Re: Birriwa Solar and Battery Project (SSD-29508870): Request for additional information

The purpose of this letter is to respond to the request for additional information relating to the Birriwa Solar and Battery Project (the project), received from the Department of Planning, Housing and Infrastructure (DPHI) in a letter dated 8 April 2024. The request relates to additional information regarding the following:

Viewpoint - 4 (R7)

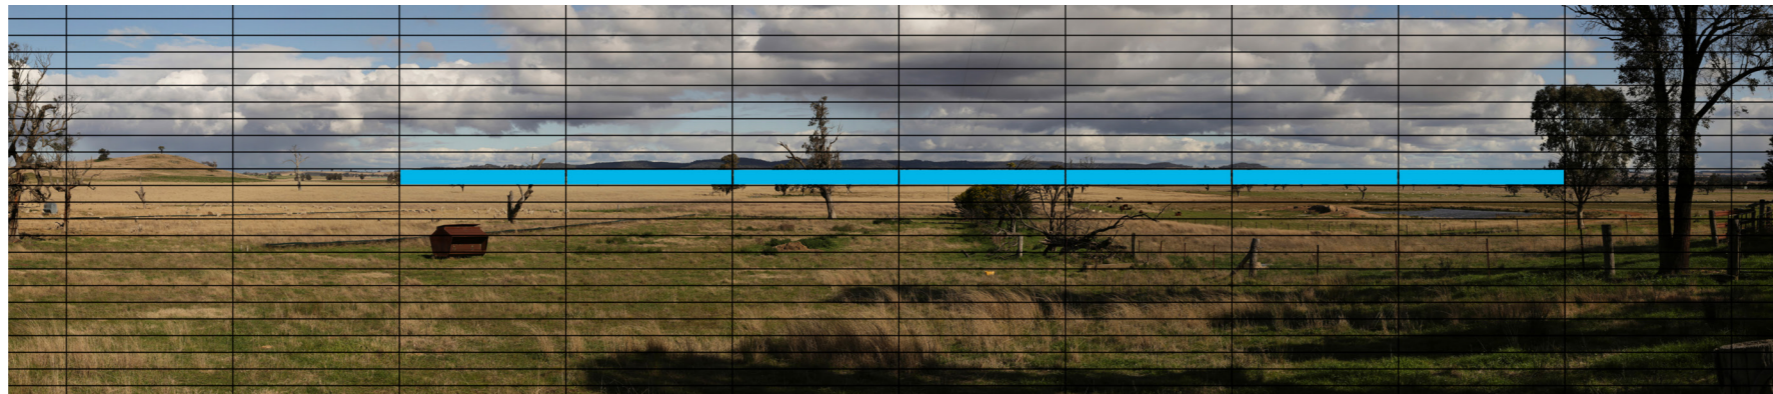
The visual impact rating at Viewpoint 4 is very low and therefore the rating at R7 is considered low.

Portions of the project will be visible above the tree line from this viewpoint. However, most of the project is screened from view by the existing trees, giving it a very low rating.

Dwelling R7 is located 155 m south of this viewpoint and it is slightly higher in elevation. The higher elevation would theoretically expose more of the project. However, the visible portion of the project would not increase significantly, giving R7 a visual impact rating of low.

Viewpoint - R12

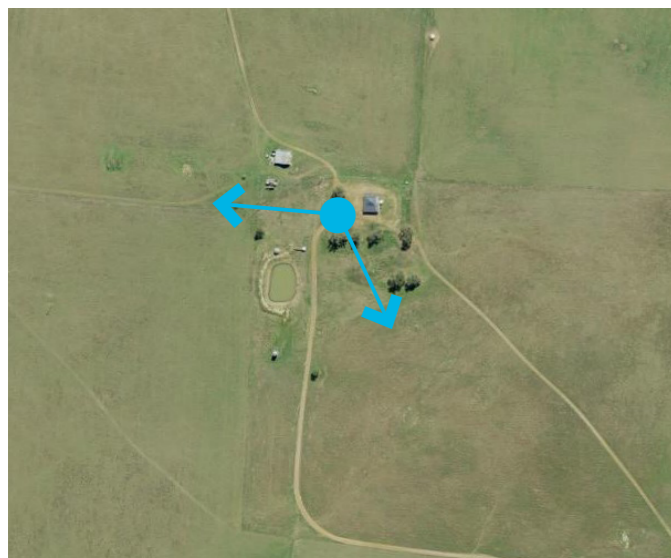
The visual impact rating at R12 is low.

While the project will be visible from this property, the impact is low as the distance is significant and views will be filtered by intervening vegetation.

Figure 1.0

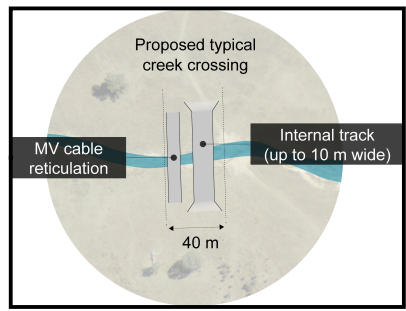
An updated site layout of the project is included as Attachment 2 to this letter.
